CERTIFICATE OF APPROPRIATENESS

Property: 208 Travis St, Lots 1, 2, 3, 9, 10 & 11, Block 19, Southside Buffalo Bayou Subdivision. The property includes a historic eight-story brick residential/commercial building situated on a 10,430 square foot (100' x 103') interior lot.

Proposal: Alteration – Storefront. Alter four of six non-original storefront sections within two bays.

**EXISTING STOREFRONT DETAIL WITH PROPOSED DOOR
(CURRENTLY INSTALLED)**

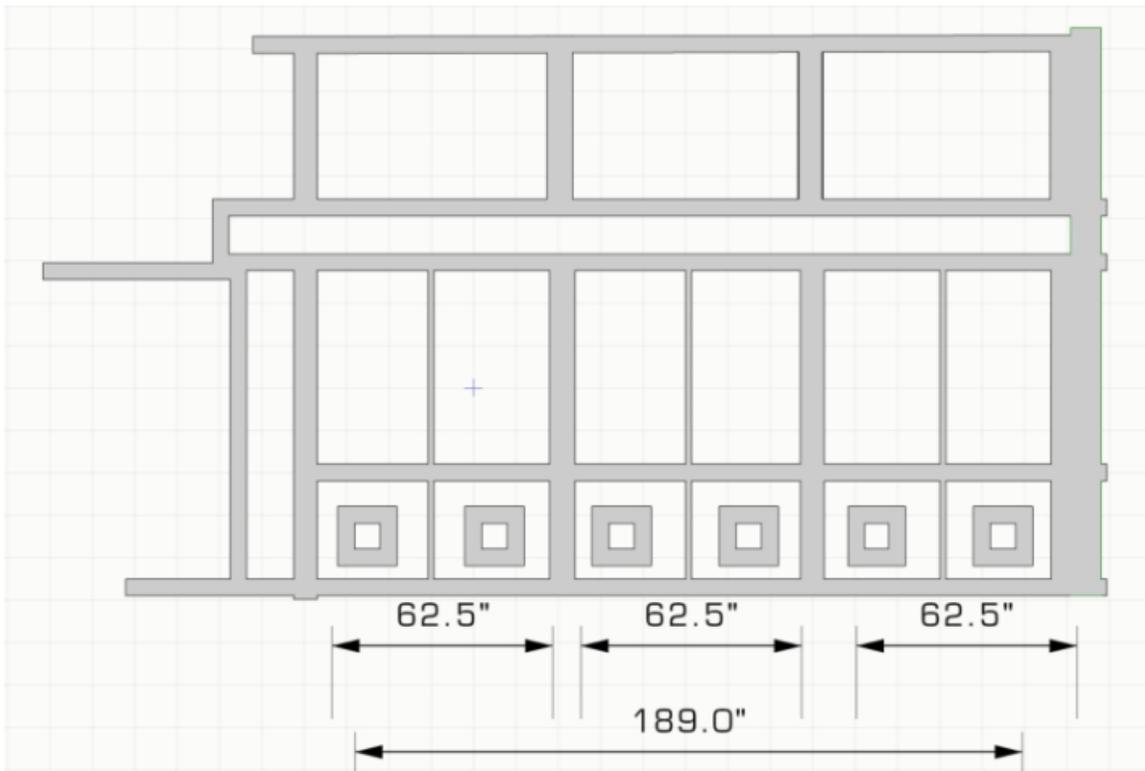
<i>A solid entry door is not compatible with historic storefront systems or the existing storefront system and therefore does not retain or preserve the historical character of the property.</i> | |

<i>The proposed door does not preserve the distinguishing qualities or character of the building because it is not predominantly glass. A solid entry door is not compatible with historic storefront systems or the existing storefront system.</i> | |

<i>The existing storefront system is characterized by glass and transparency. Since the proposed door is not predominantly glass, it is not compatible with the character of the property.</i> | |

Recommendation: Partial Approval: Approval for the alterations to Bay 4-Sections D, E, and F; denial for the installation of a paneled wood door in Bay 3-Section C.
